Solution for A1 Port Analogue Regulator Wrong Grounding

RIKEN/RBRC
Itaru Nakagawa

From: Itaru Nakagawa <itaru@riken.jp>
Date: Thursday, March 17, 2022 at 4:53 AM
To: Melynda Brooks <mbrooks@lanl.gov>
Cc: jin huang <jhuang@bnl.gov>
Subject: [EXTERNAL] Column-A Station-1 port of FVTX ROC board

AGND_2 Trace on ROC

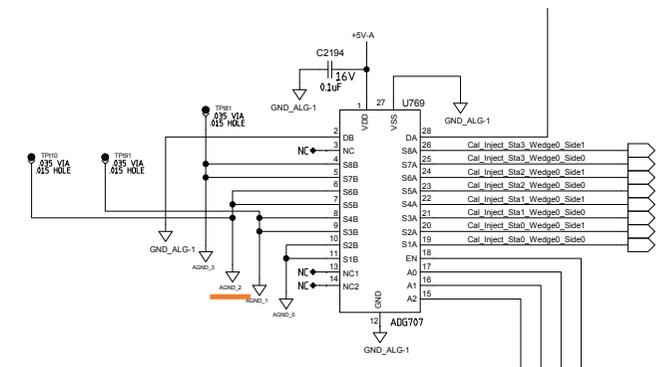
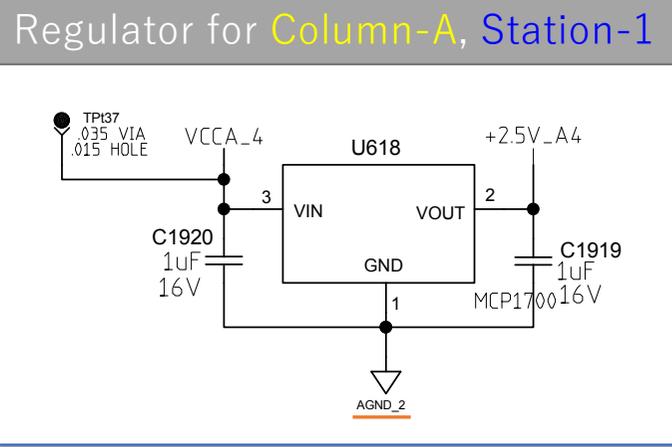
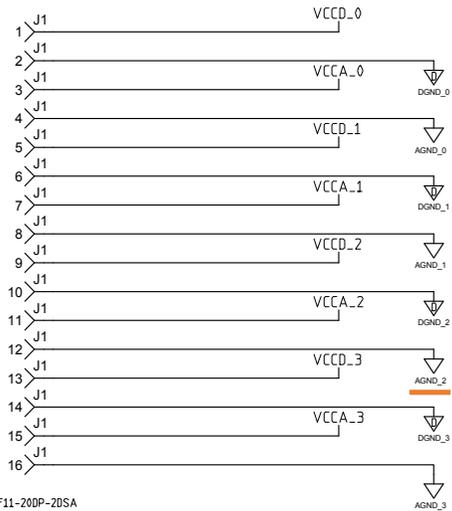
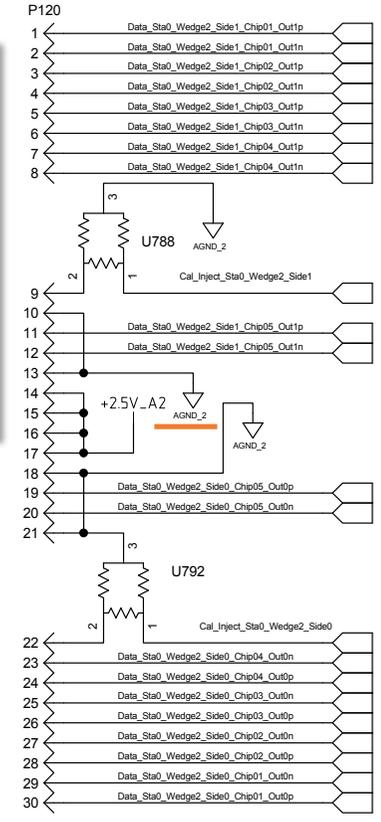
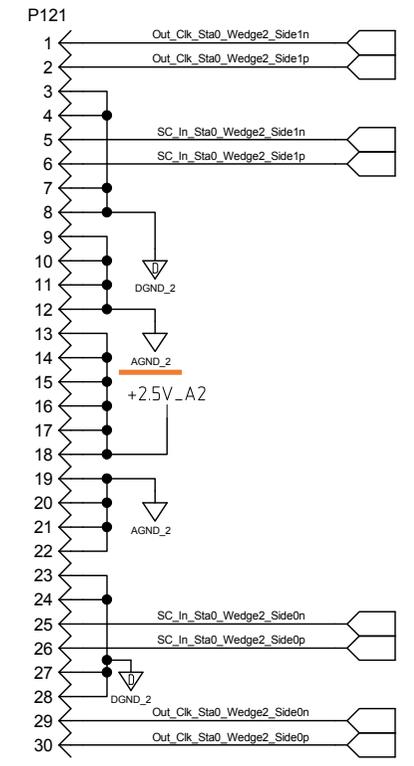
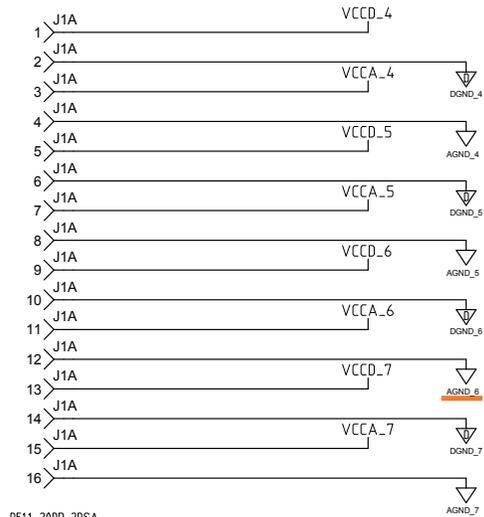
Evidently, there is mis-match in the analogue GND. Station-0 and Station-1 are mixed.

AGND_4 Trace on ROC

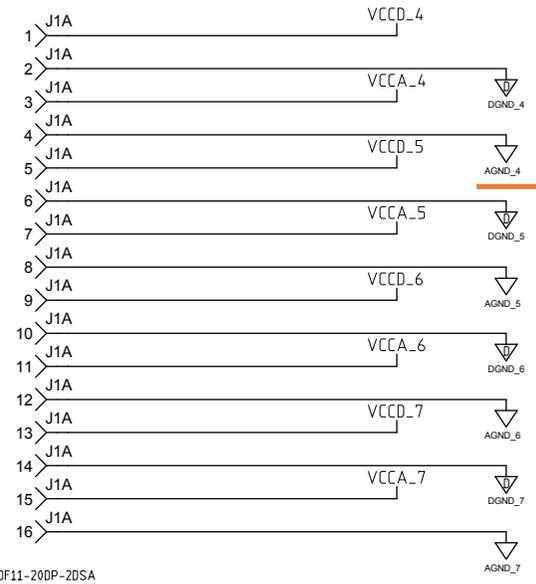
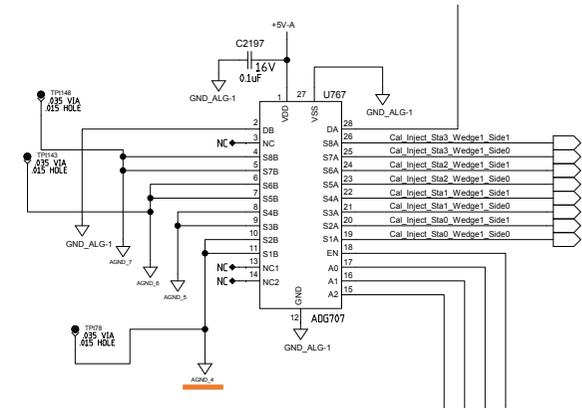
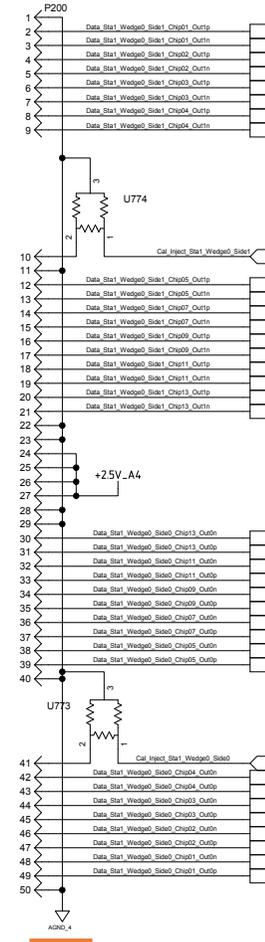
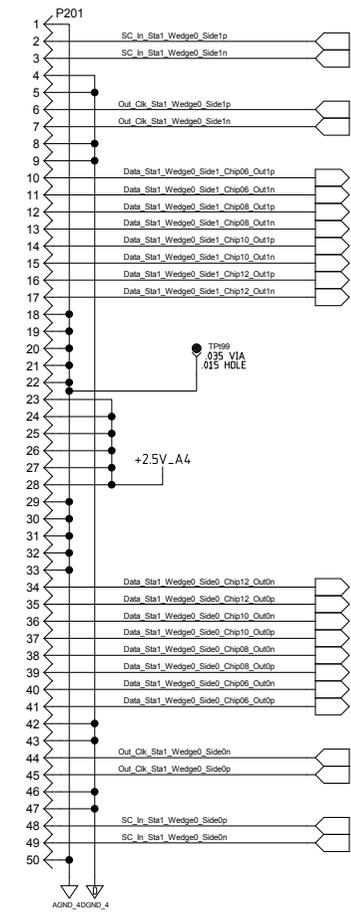
No regulator is wired from AGND_4

The AGND_4 analogue ground is not wired to any regulators.

AGND_2 Trace on ROC

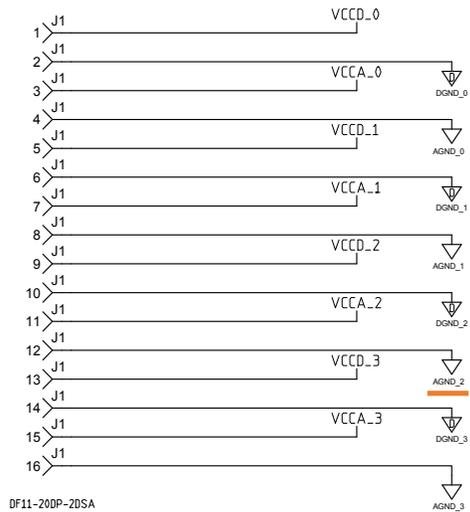
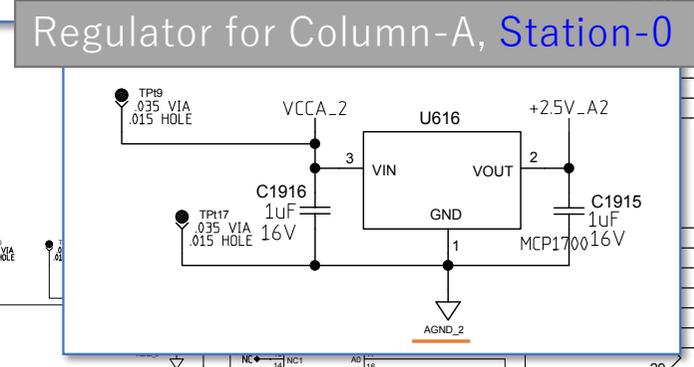
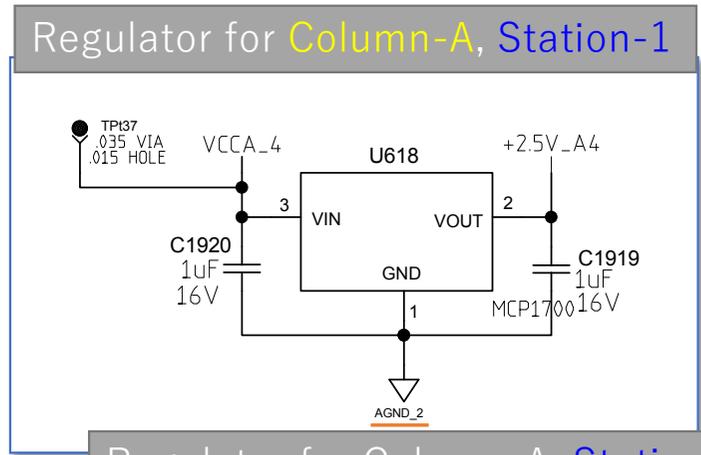
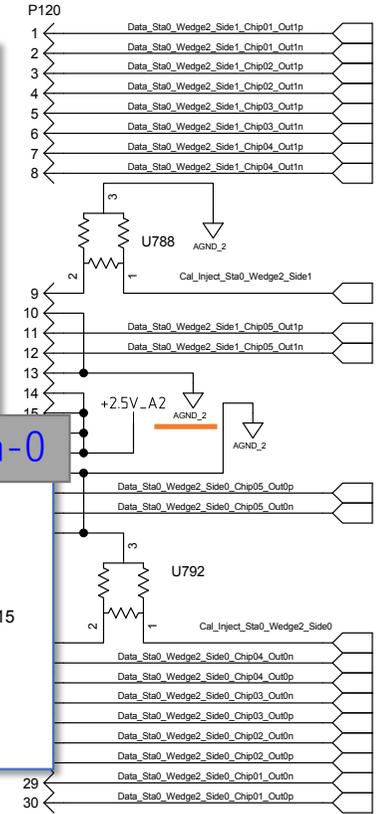
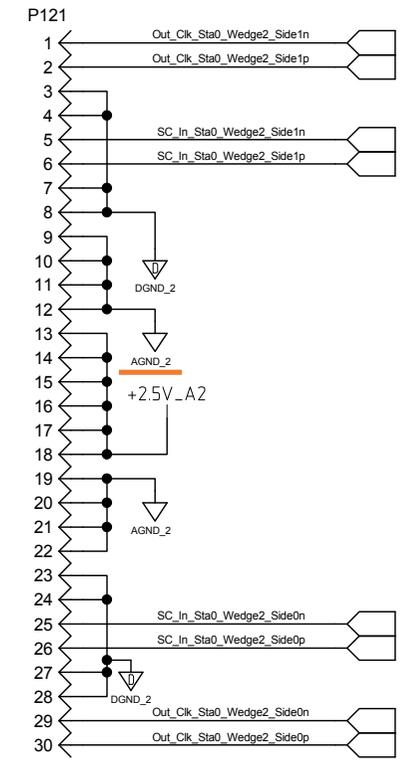
I know it is getting past for you, but I have to bother you again. I found mysterious circuit design in the ROC and I need to confirm with you. See attached summary file. The issue is in the analogue regulator for the FPHX of the A1 port (Column-A, Station-1). The ground of the regulator suppose to be wired to AGND_4 I believe, but it is actually wired to AGND_2. It is hard to imagine the circuit was designed like this on purpose. As I commented in slide 6, I guess it didn't cause severe effect for FVTX, but I would appreciate if you aware of any misbehavior of wedges connected to the A1 port commonly. I am seeking for any portable solution to fix this because I am afraid our condition can be different from FVTX. If you have any suggestion or idea, I also appreciate.

AGND_2 is shared with Column-A, Station-0 and Station-1 analogue regulators.

Yes, the grounding is a mistake. The primary result of the mistake is that the non-diagonal wedges needed to be calibrated in pairs so that the grounds got connected correctly when calibrating. Other than that, function was okay.

FVTX Case Circuit Diagram

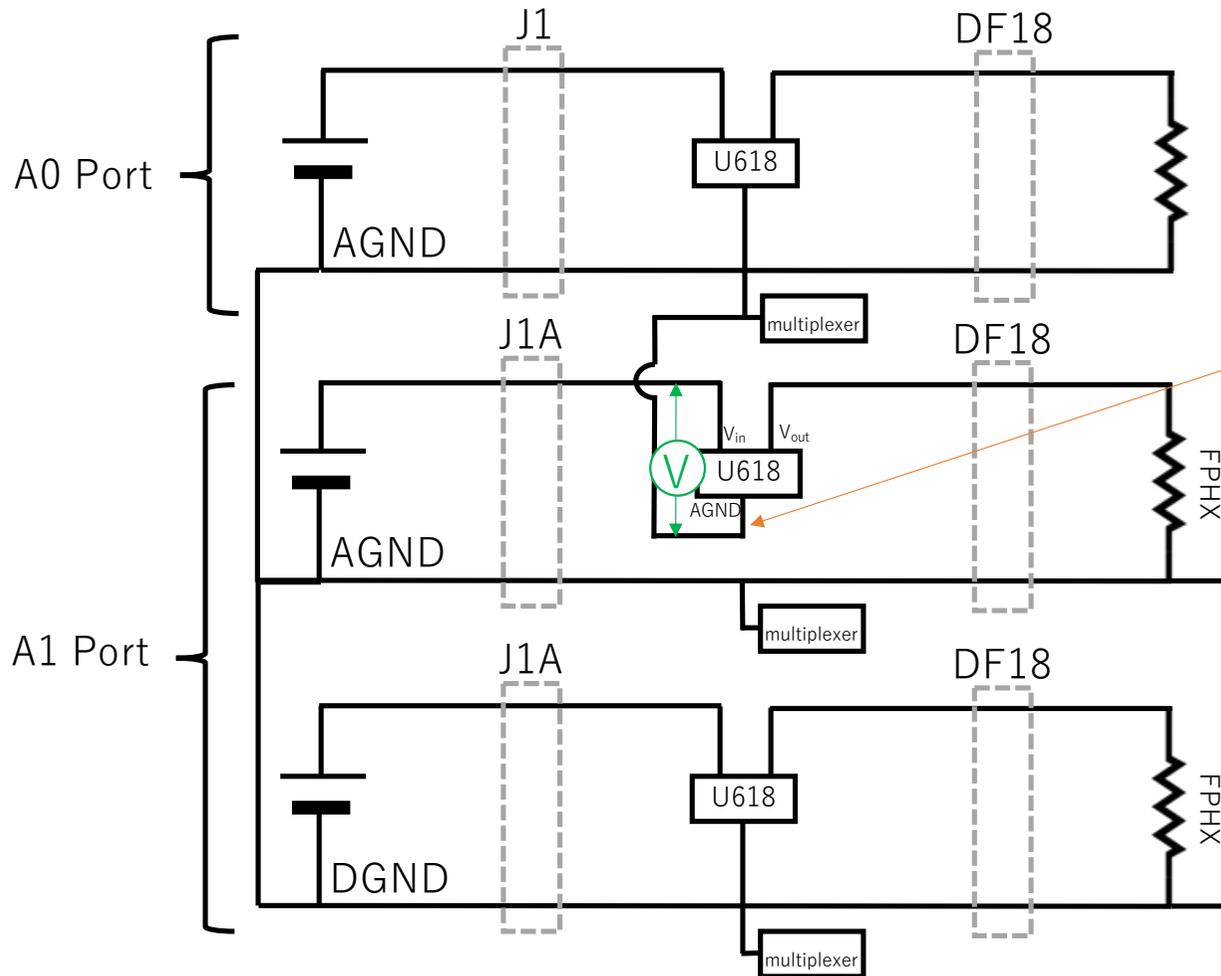
AGND is provided by A0 power supply which is likely to be shared with the GND of A1 analogue power supply. This circuit effectively secures stable operation of U618 regulator presumably.

Not sure how stable U618 regulator output is with the floating ground with open J1 and DF18(P100,P101) for INTT case. It is not guaranteed INTT works as well as FVTX.

How can we recover?

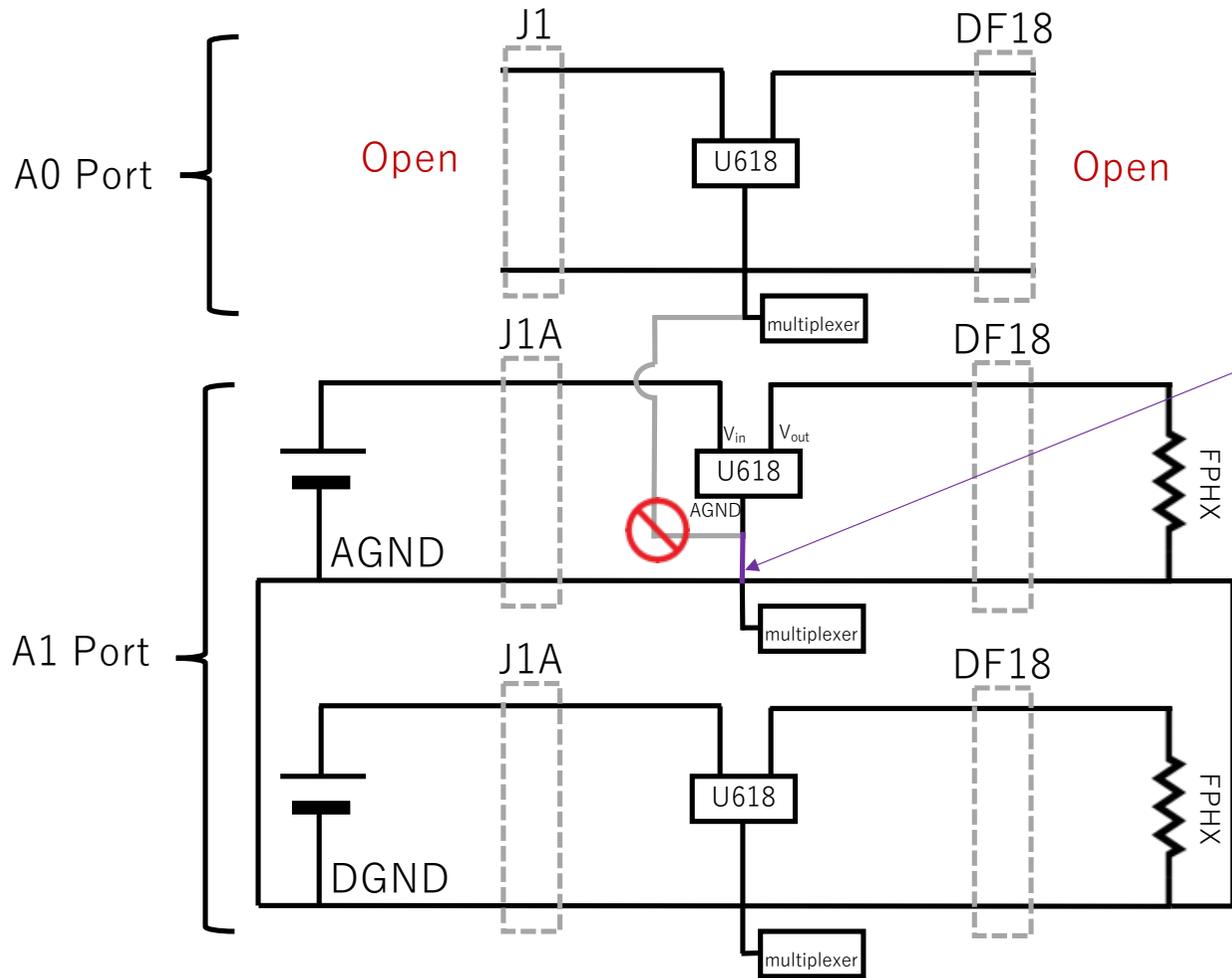
Need to bridge between primary side and back side of the ROC boards. This is not trivial recovery. Keep searching for more portable solution.

Disable AGND_2 connection and Install new jumper cable.

Column-A1 Analogue Regulator Measurement

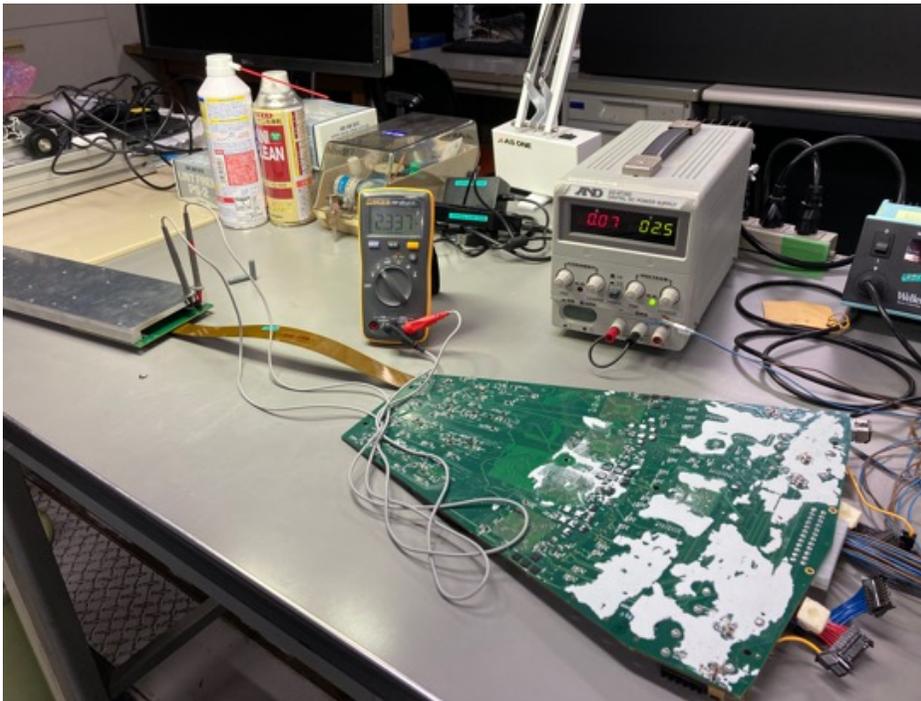
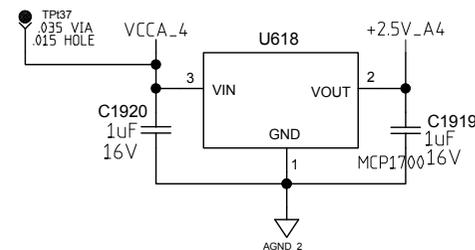
The output voltage at analogue regulator is 2.8V.
Observed +0.4V higher voltage at the interception board.
Presumably it is caused by the ground level difference.

A1

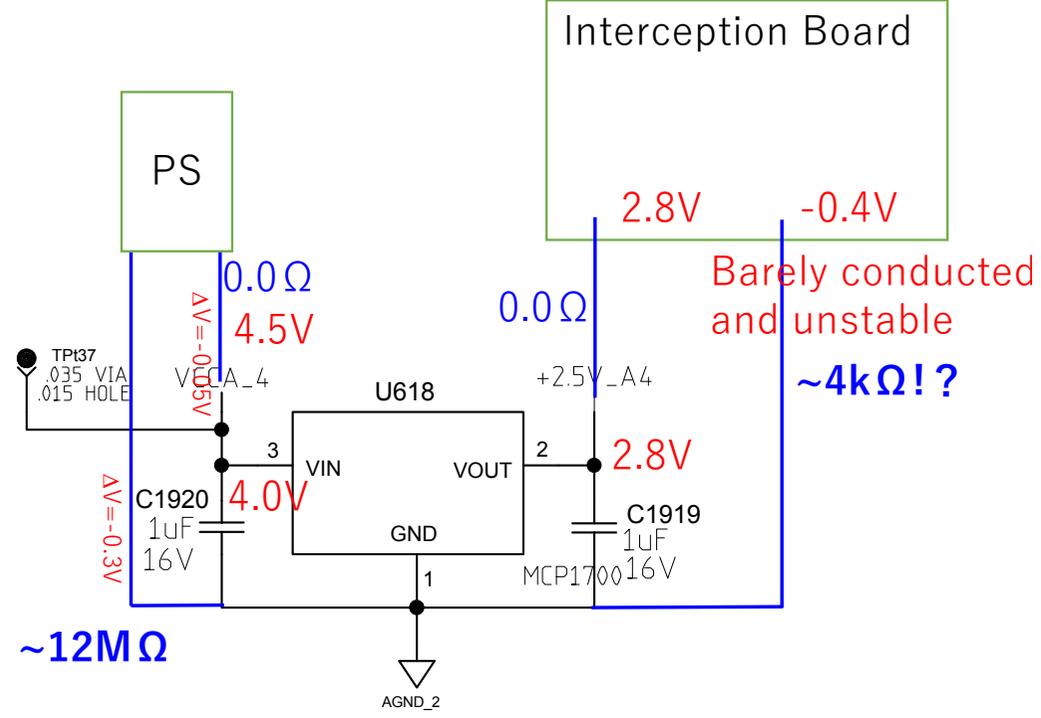
Analogue GND Line is **not** directly connected to AGND of Interception board

Barely conducted and unstable
~4kΩ!?
